DA NO: DA-2021/130

ADDRESS: 20 STRATHALLEN AVENUE. NORTHBRIDGE NSW 2063.

PROPOSAL: DEMOLISH EXISTING DWELLING AND CONSTRUCT THREE

RECOMMENDATION: REFUSAL

Section provided with the application

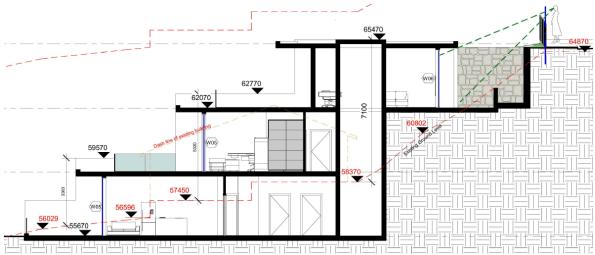
The front of the site is proposed to be occupied by pedestrian ramps that run parallel to the frontage and by a ramp for the motorcycle spaces. A narrow strip of landscape is located between the pedestrian ramp and the site front boundary. The proposed building and pathways forward to the building alingment are uncharacteristic for the streetscape and will appear as a large paved area at the level of the street, when seen from Strathallen Avenue.

The proposal will require removal of all trees on site (7) and one (1) public tree and the landscape plans do not provide sufficient replacement trees. Towards the front and sides of the site (north, east and west) there is insufficient space to accommodate trees to screen the proposed built form.
